DEVELOPMENT REVIEW BOARD SUPPLEMENTAL SUBMITTAL

RE: PR-2018-001579 – WINROCK TOWN CENTER SI-2021-00304 SITE PLAN SI-2021-00305 SITE PLAN AMENDMENT PS-2021-00040 SKETCH PLAT

In response to comments provided on March 31, 2021, we have the following responses which correspond to our platting & site plan documents and re-submitted project sheets.

WINROCK TOWN CENTER PARK & ASSOCIATED BUILDINGS

A004

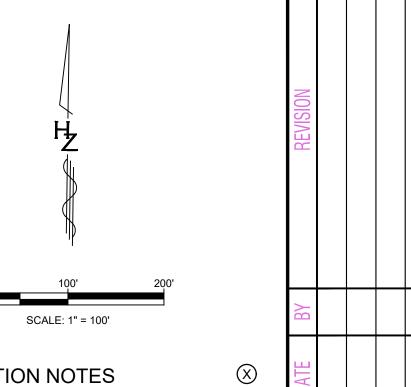
- Please provide details for the patio and gazebo.
- Show any signage that will be associated with the park.
- A platting action is needed if you plan to create a separate parcel that can be conveyed to another entity.
- Elevations were provided as part this submittal. Are these illustrative or part the items that
- the DRB will be reviewing?

Applicant Response: A virtual meeting was held on April 20, 2021 with members of the design team and Ms. Maggie Gould, DRB Planner. All comments were discussed and clarifications have been provided in our re-submittal elevations sheets A004, A003 and A20.

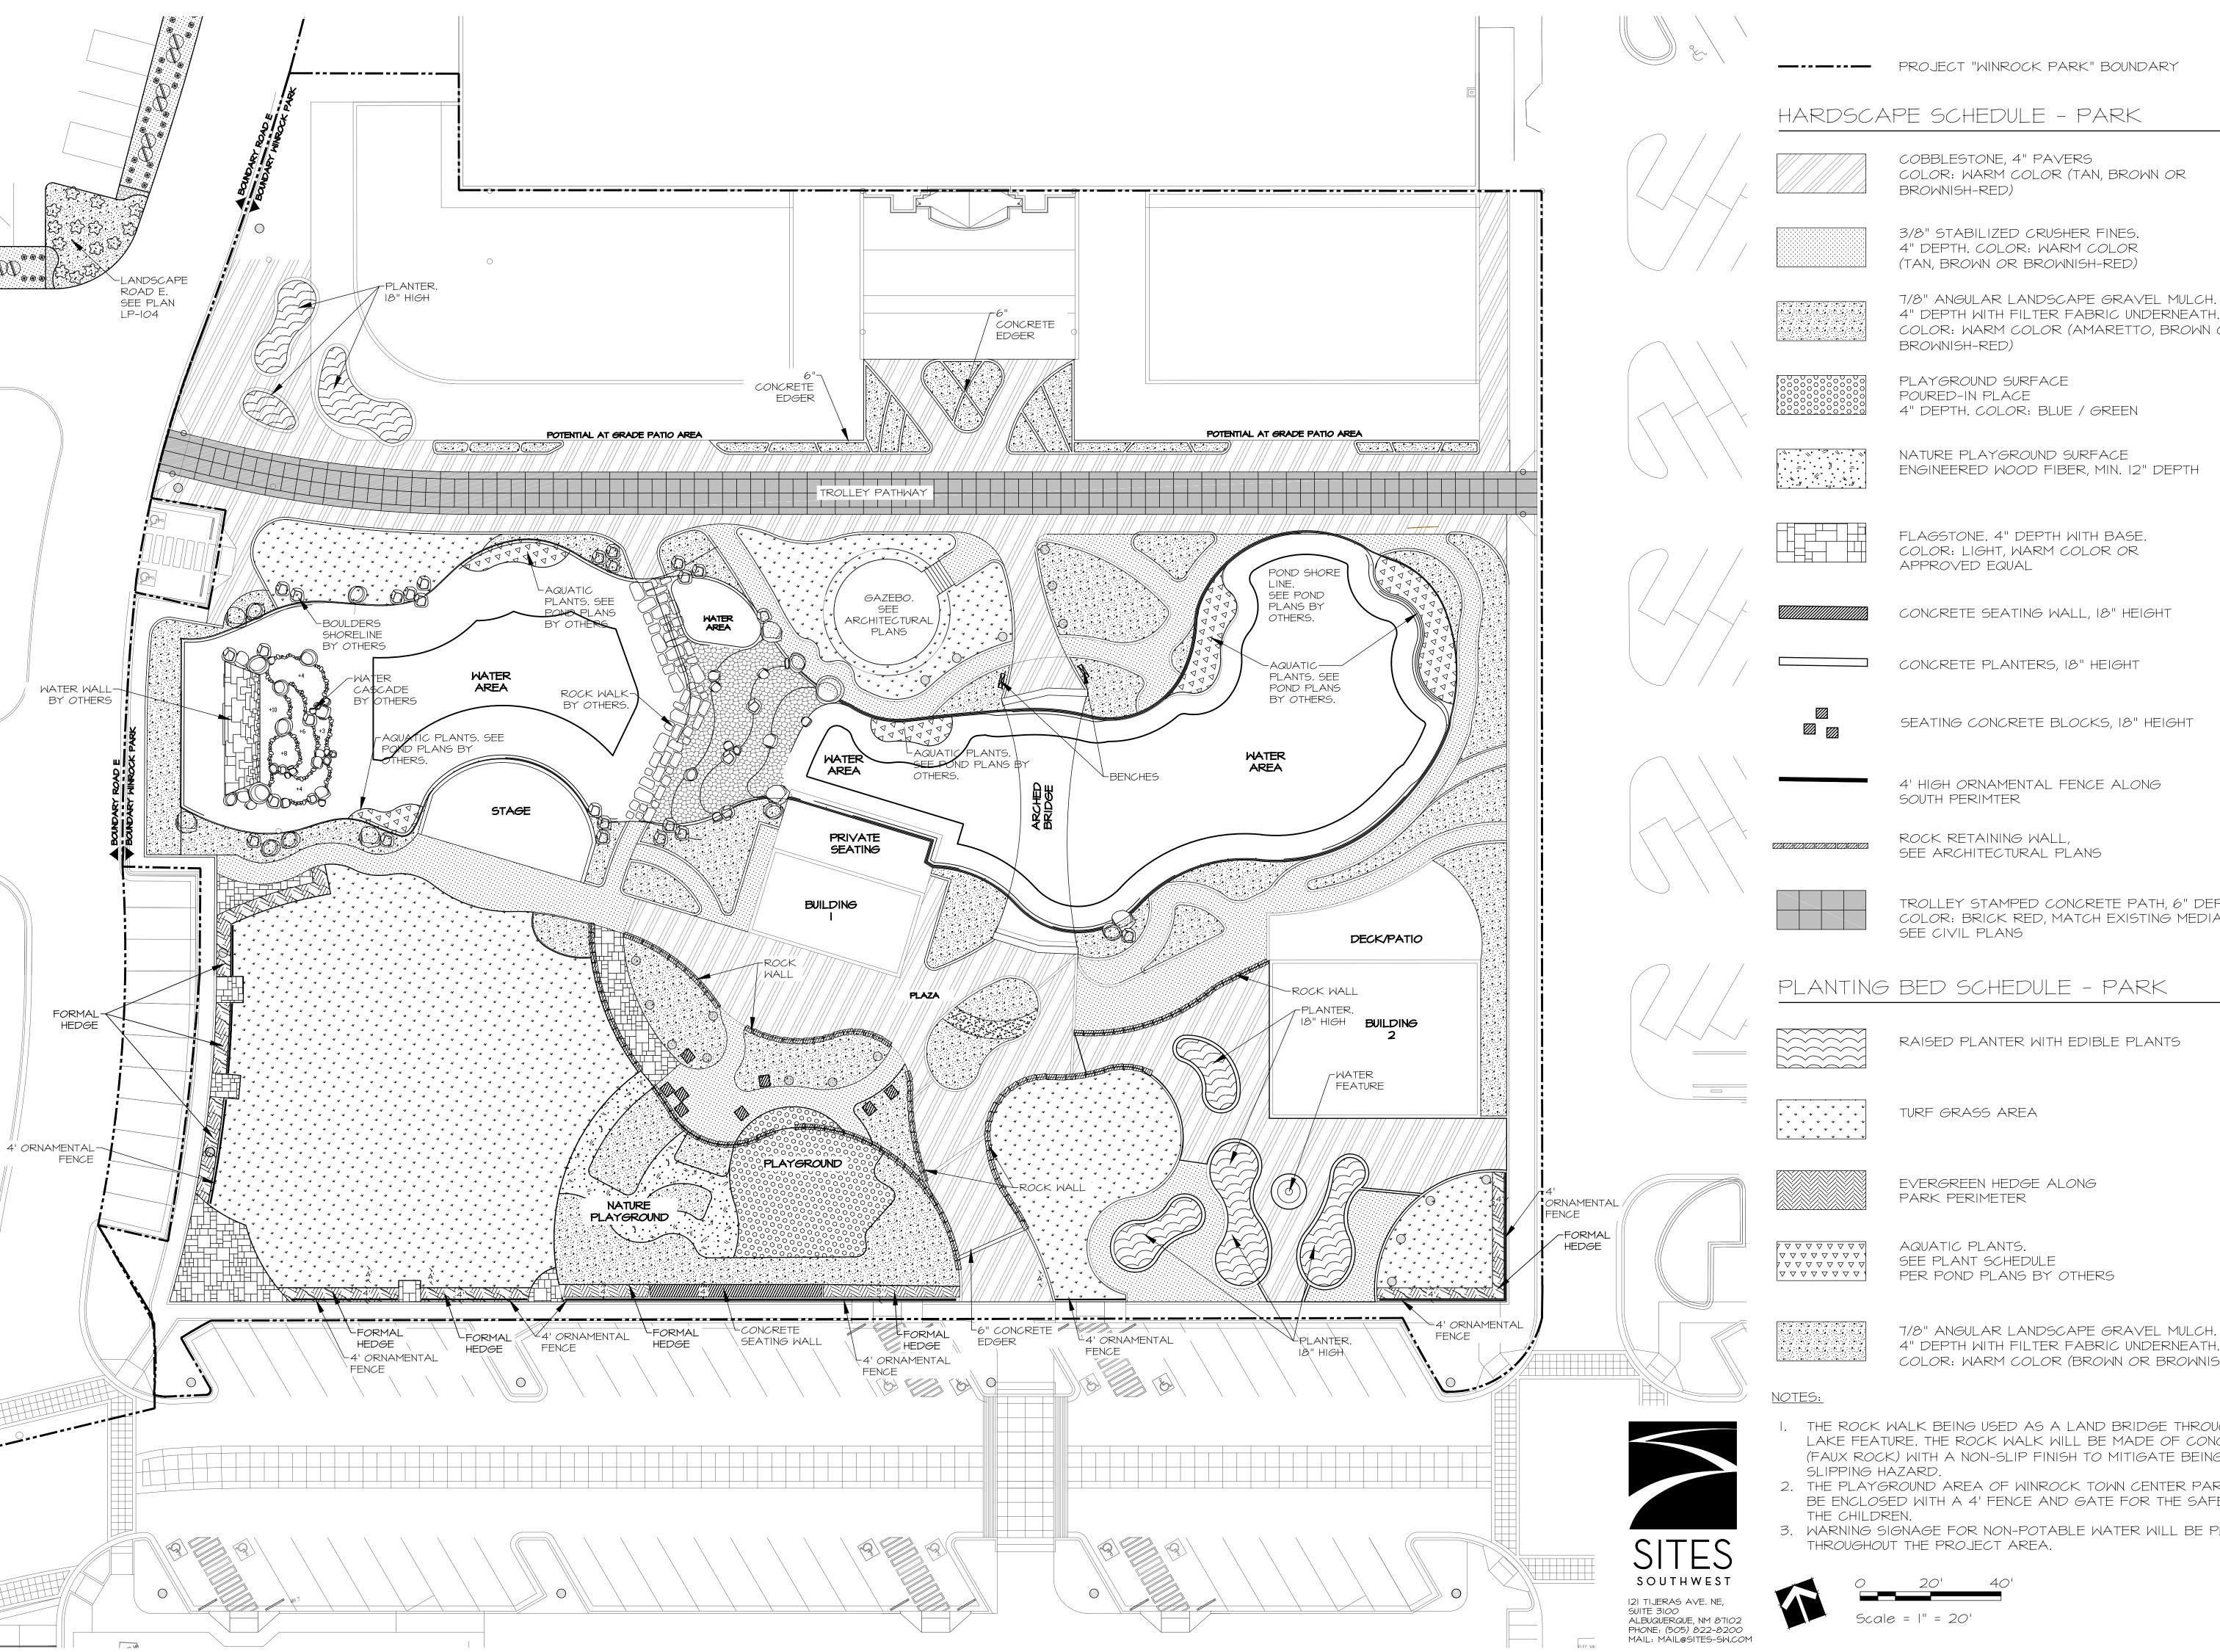
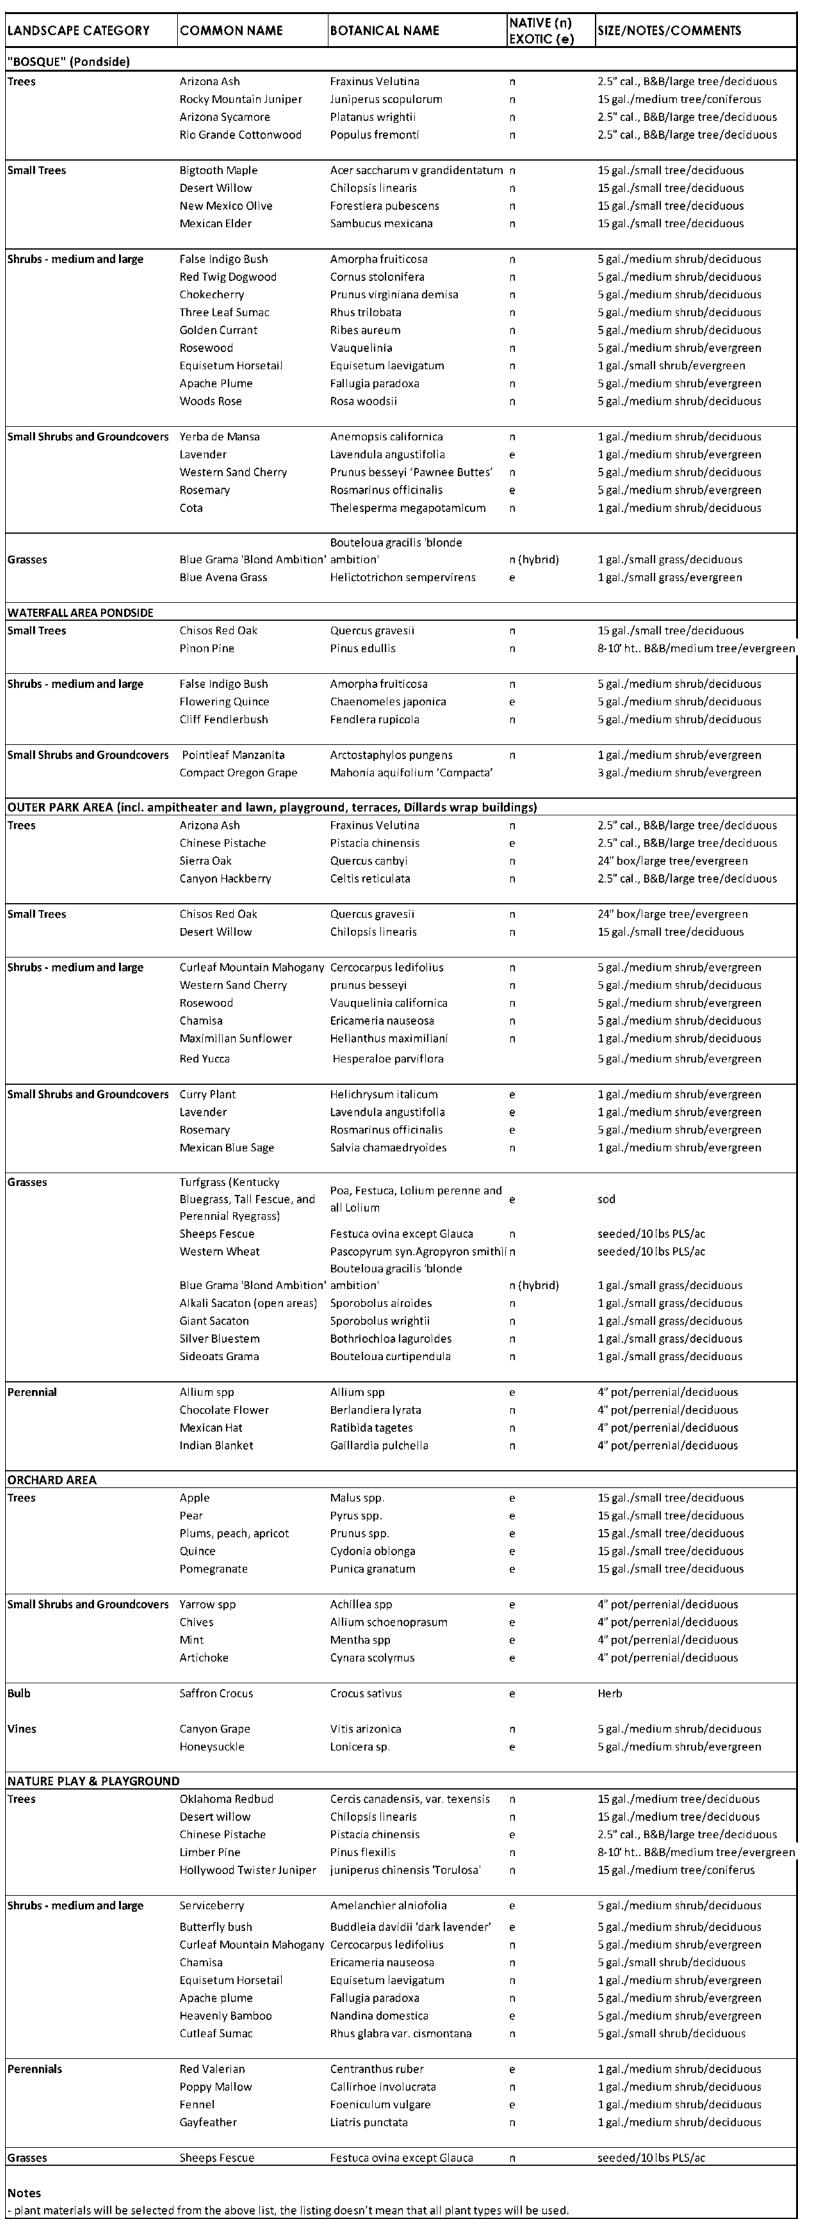
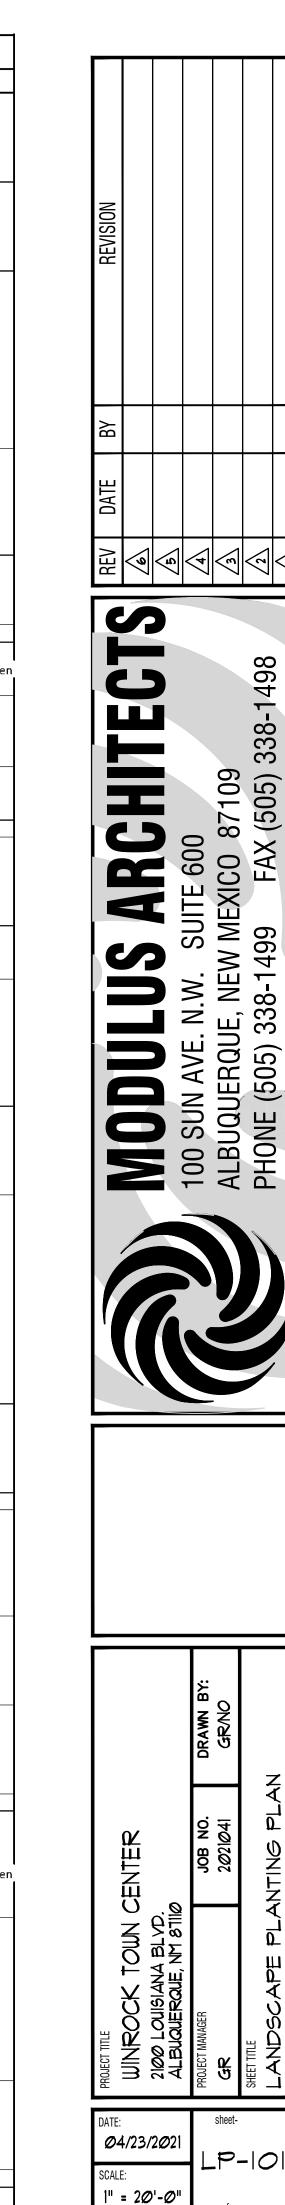
3. PRD has concerns over the "Rock Walk". Please note how a slipping hazard will be prevented.

Applicant Response: The rock stepping stones being used as a land bridge through the lake feature at Winrock Town Center Park will be made of concrete (faux rock) with a non-slip finish to mitigate the potential for the stepping stones being a slipping hazard for users.

- THE ROCK WALK BEING USED AS A LAND BRIDGE THROUGH THE LAKE FEATURE. THE ROCK WALK WILL BE MADE OF CONCRETE (FAUX ROCK) WITH A NON-SLIP FINISH TO MITIGATE BEING A
- THE PLAYGROUND AREA OF WINROCK TOWN CENTER PARK WILL BE ENCLOSED WITH A 4' FENCE AND GATE FOR THE SAFETY OF
- 3. WARNING SIGNAGE FOR NON-POTABLE WATER WILL BE PLACED
